# UNITED STATES PATENT AND TRADEMARK OFFICE

10/531,962

<b>Office Action Summary</b>	<b>Application No.</b> 10/531,962	<b>Applicant(s)</b> CIOC ET AL.	
	<b>Examiner</b> GERARD T. HIGGINS	<b>Art Unit</b> 1794

## **DETAILED ACTION**

Fig. 5. Cross-sectional view of the sample disk.

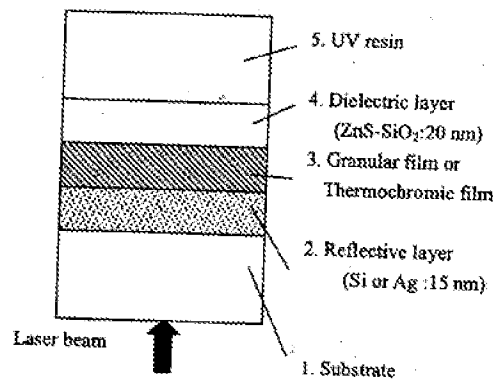
Nomura et al. disclose the structure of an optical recording medium in their Figure 5.

Nomura et al. disclose that their granular film comprises small silver particles, wherein reflectivities are changed by increasing the silver particle size. The granular film layer **3** is analogous to applicants' storage material (ion-doped layer), the substrate **1** is analogous to applicants' material layer (Nomura et al. discloses the substrate may be polycarbonate, same as applicants), there is a reflective layer **2** arranged in between the storage material and the material layer, and there are tracks (optically functional structures) on the polycarbonate substrate (pp. 1877, col. 2).

Since Nomura et al. and Wu are both drawn to optical recording media featuring layers with dispersed metal particles therein; it would have been obvious to one having ordinary skill in the art at the time the invention was made to combine the glass substrate with the IIES layer of Wu into the disk structure Nomura et al. The results of this combination would have been predictable to one having ordinary skill in the art of CD/DVD manufacture; furthermore, each element would have performed the same in combination as they had separately. Additionally, Nomura et al. disclose using his recording medium to increase data capacity and recording density, which is extremely beneficial in the art of CD/DVD manufacture.
